1958 Corvette: Service Bulletin: Electric Windshield Wiper Information

Subject: Electric Windshield Wiper Information
Model and Year: 1958 Passenger Cars and Trucks
Source: Chevrolet Technical Service Bulletin
Bulletin No: DR #359
Section: I
Date: May 28, 1958

FIGURE #1.

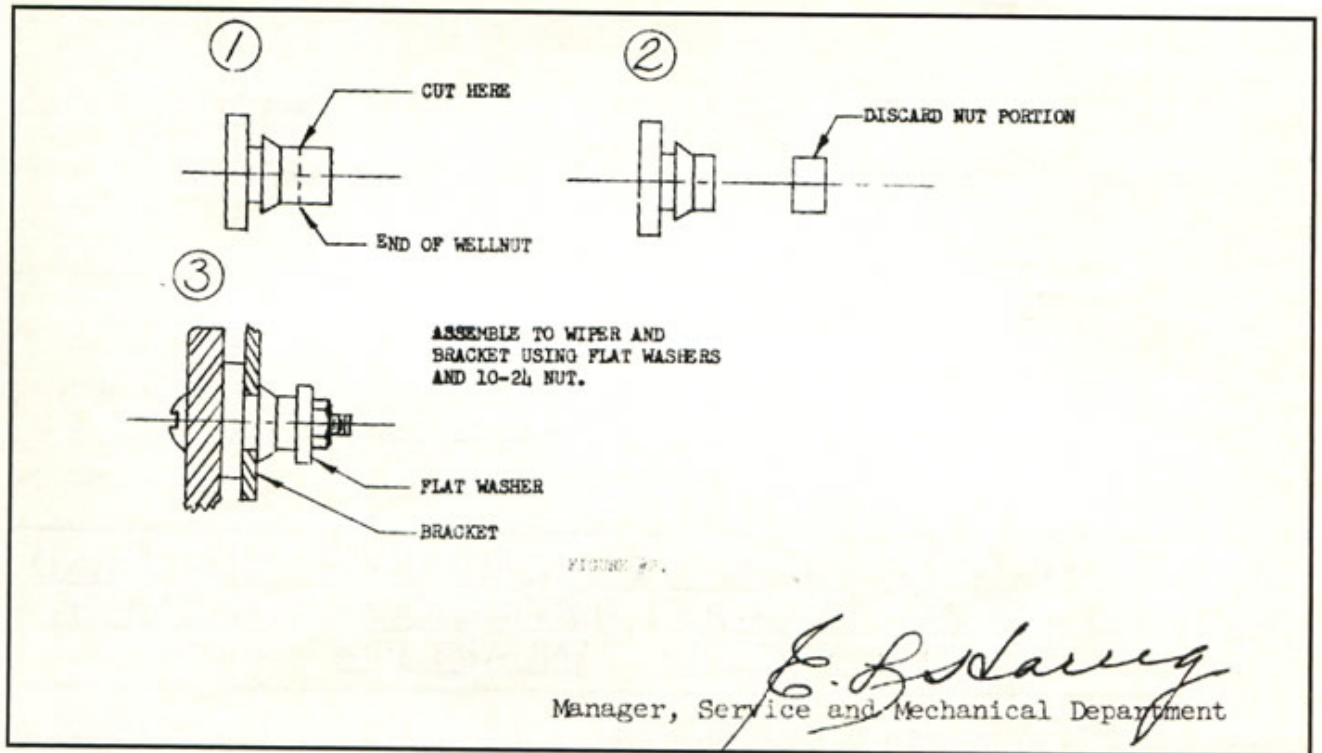
In some cases the wiper motor, after being shut off, may over travel the effective length of the parking cam and continue to run in a reverse direction. This condition may occur even though the blades are properly positioned as covered in TSB #508, DR #359.

A parking spring has been released for production and service which enables the motor to shut off without depending on the resistance of the wiper blades. The spring is designed to clear the revolving arm in the "ON" position and stop the arm in the "PARK" position when switch is turned off. Figure #1 shows installation of parking spring.

If the right hand blade slaps against the moulding excessively even though the blade is correctly positioned and parks properly, the upper cam stop is probably bent or broken. This damage can occur if the mechanism is coated with ice when the wiper is turned on.

A more durable replacement cam stop is available for service. Figure #1 shows details of installation. The existing tab must be bent flat before installation of the new stop.

SKETCH SHOWING INSTALLATION OF PARKING SPRING AND
CAM STOP ON 1956 ELECTRIC WINDSHIELD WIPERS.
